Department of Energy
Washington, D.C. 20545
Docket No. 50-537
HQ:S:82:149

MEETING SUMMARY FOR THE SHUTDOWN HEAT REMOVAL MEETING, DECEMBER 16, 1982

BRIEFING ON
CRBRP SHUTDOWN HEAT REMOVAL CONCERNS

Shutdown Heat Removal Meeting
December 16, 1982
Agreements and Commitments

DEMO DOUBLE ENDED PIPE RUPTURE RESULTS

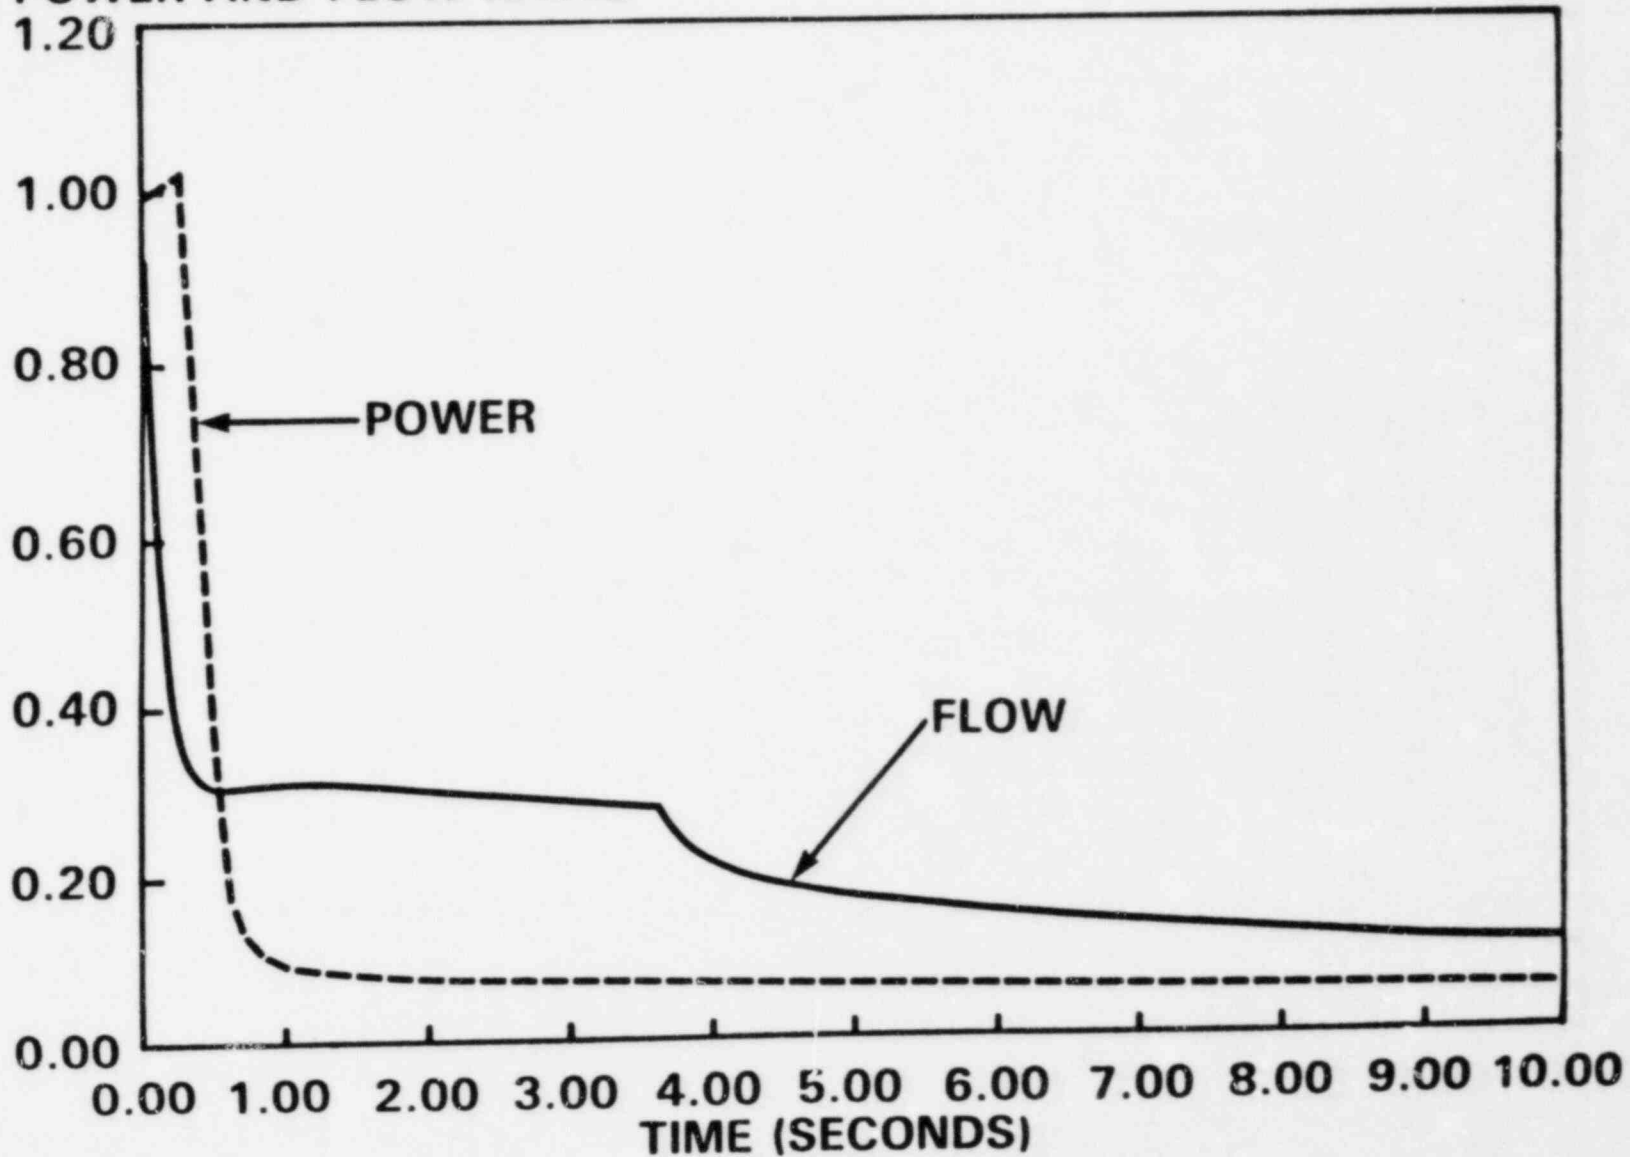
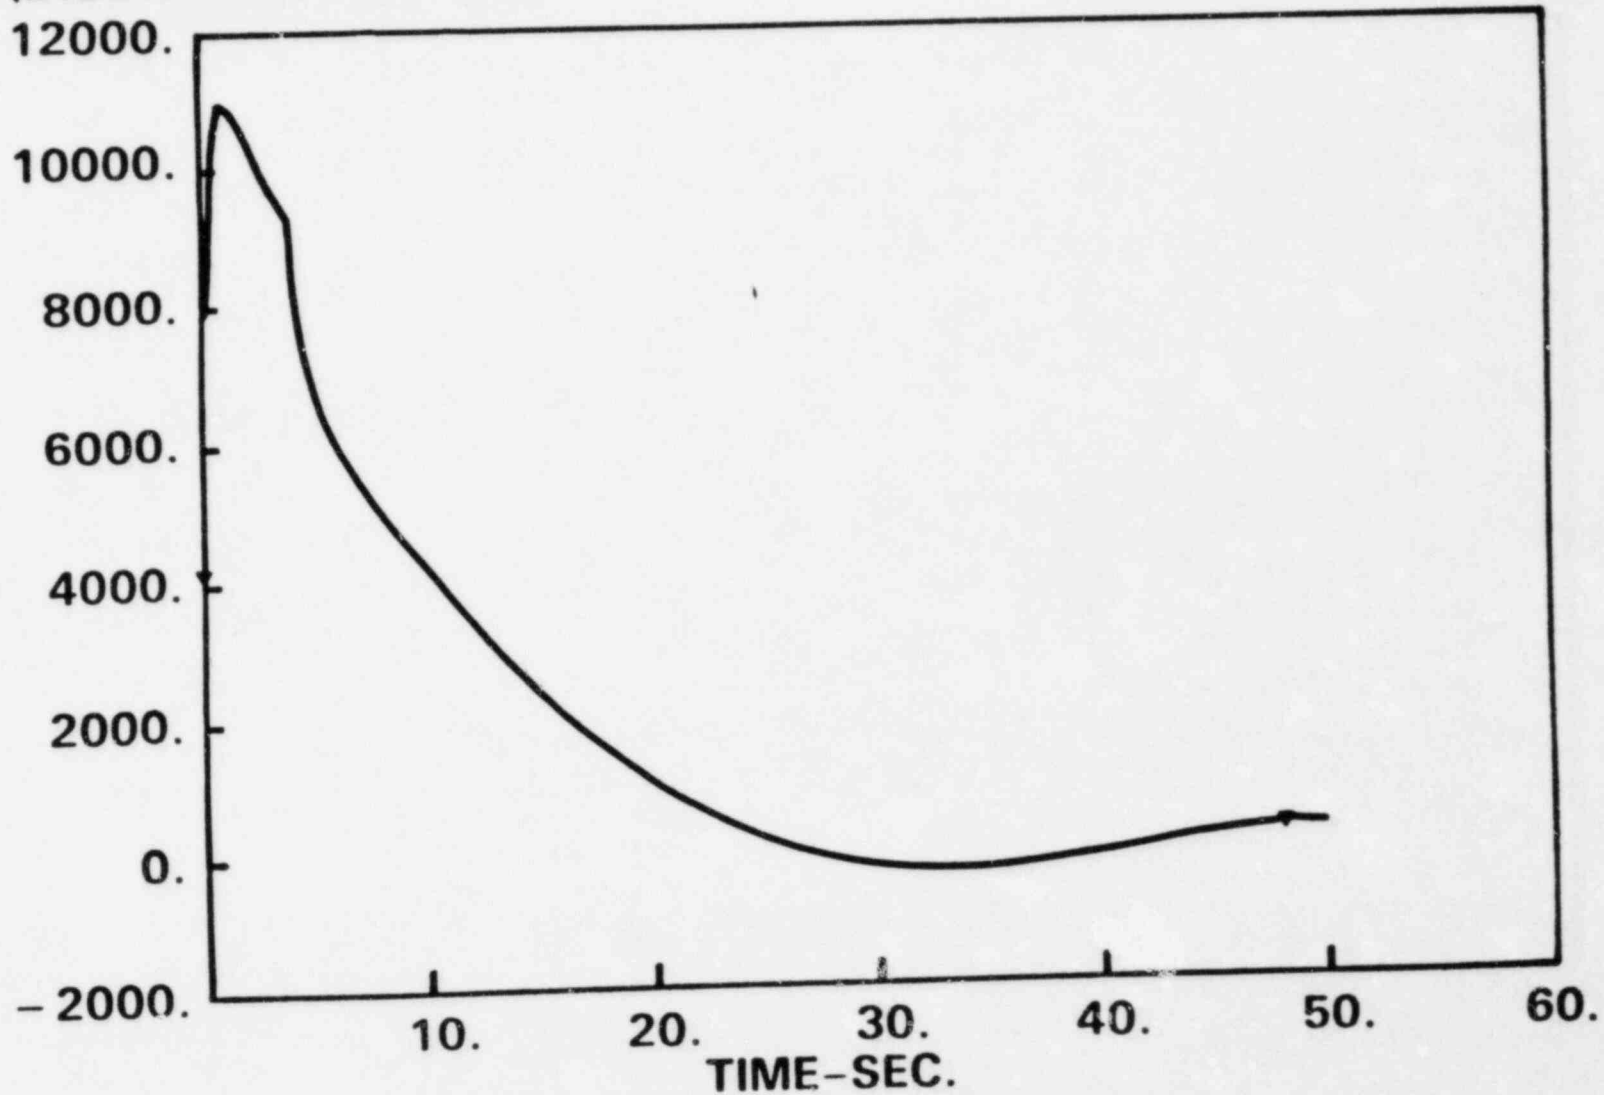
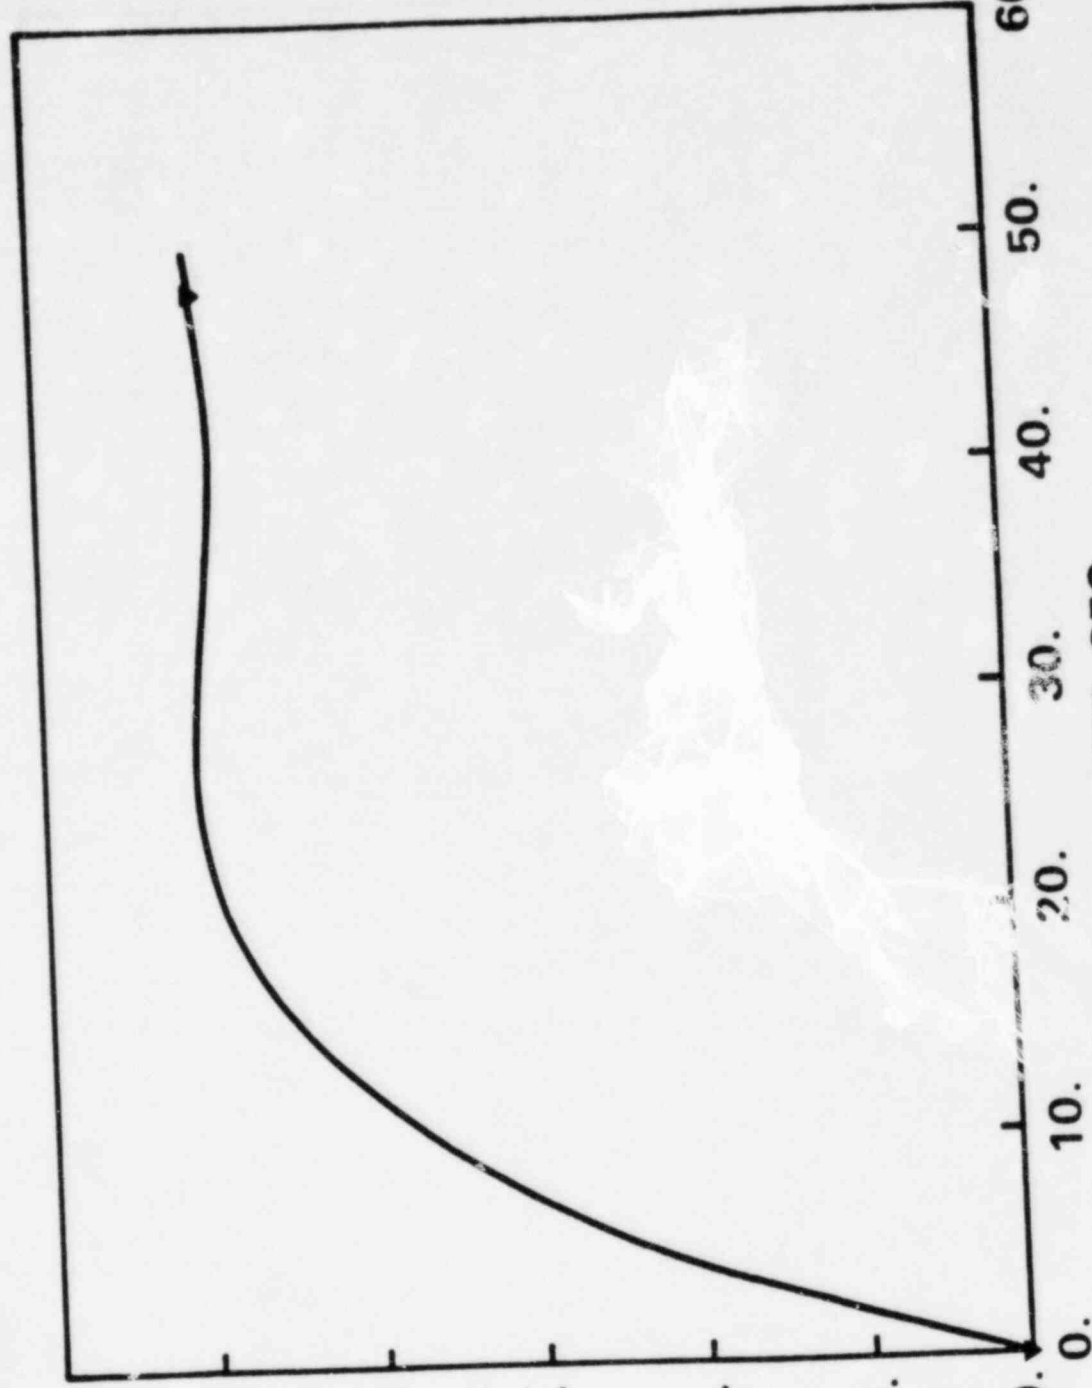
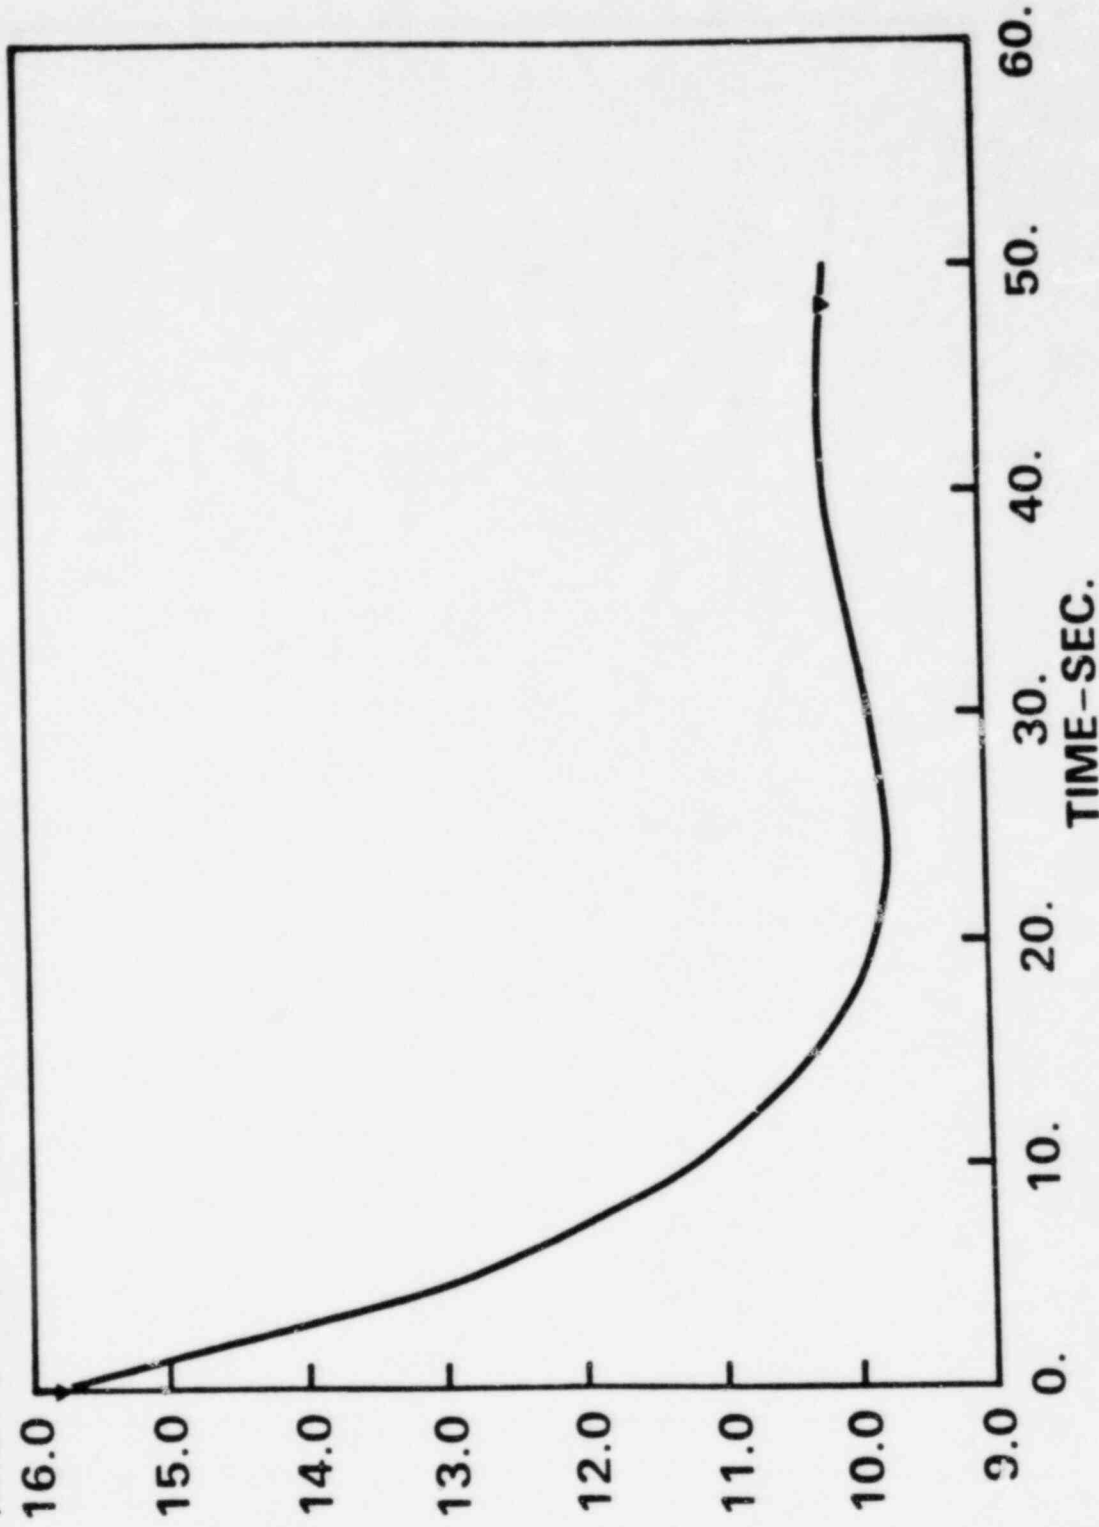
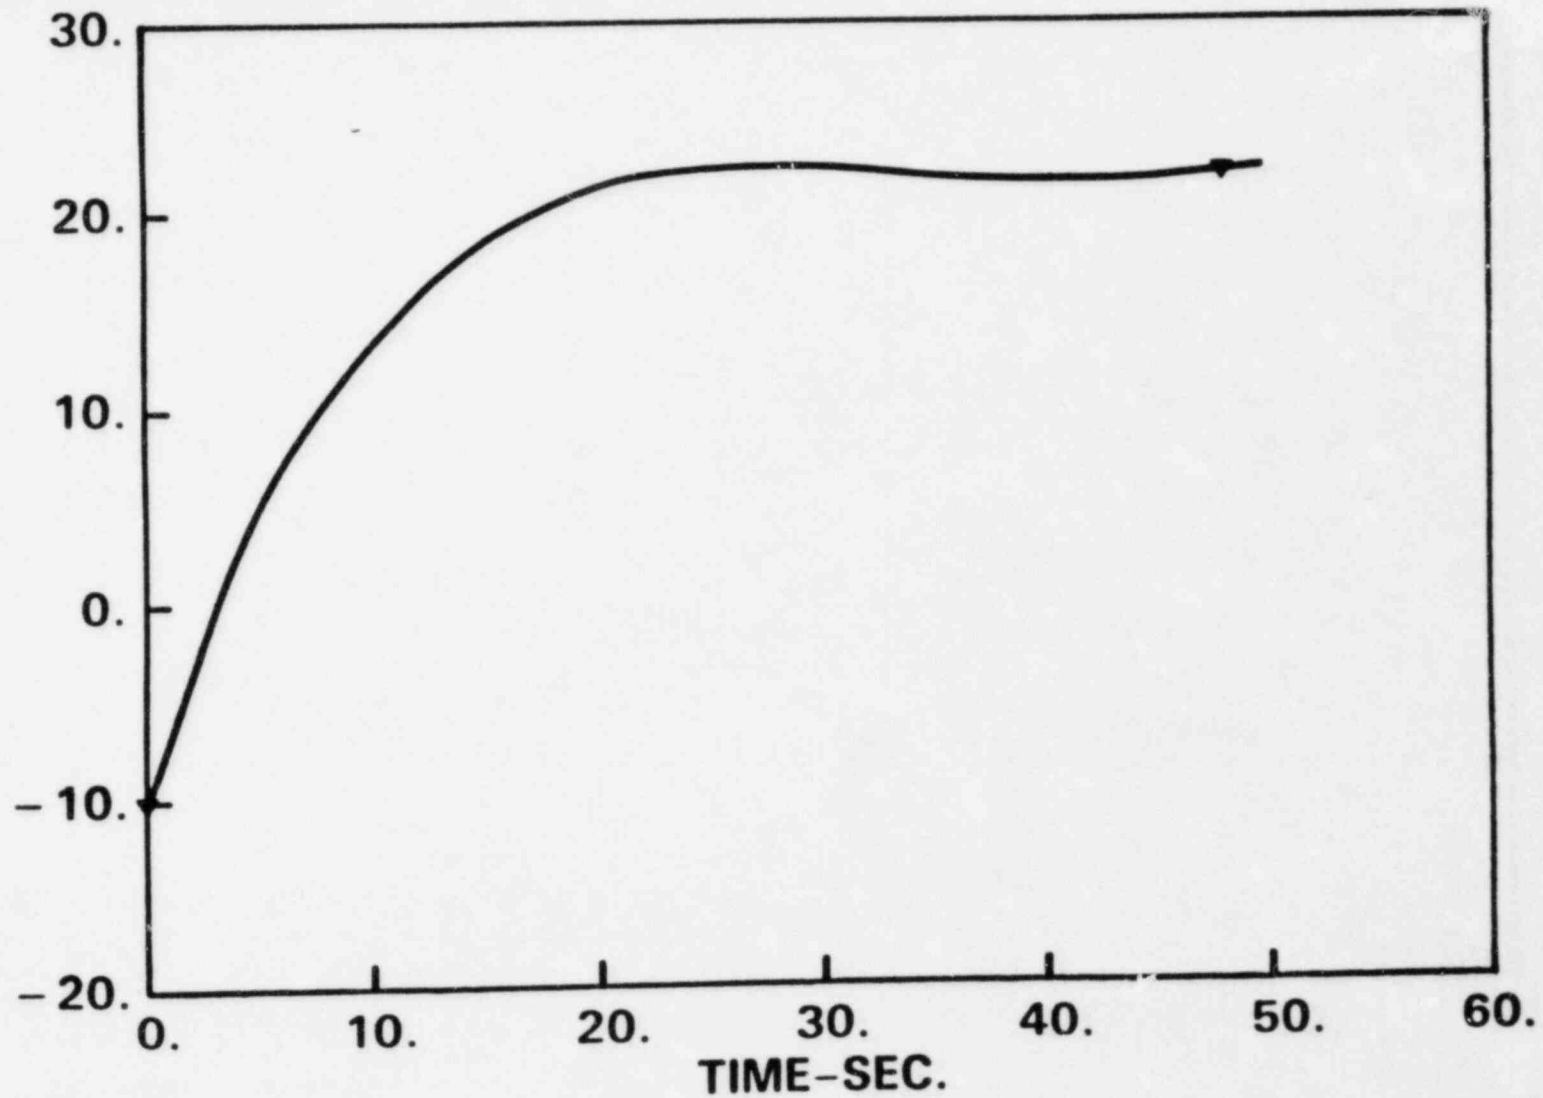
Pipe Break Analysis (see attached)

Action: The DEMO code output and assumptions used for hot leg pipe break analysis will be provided to NRC.
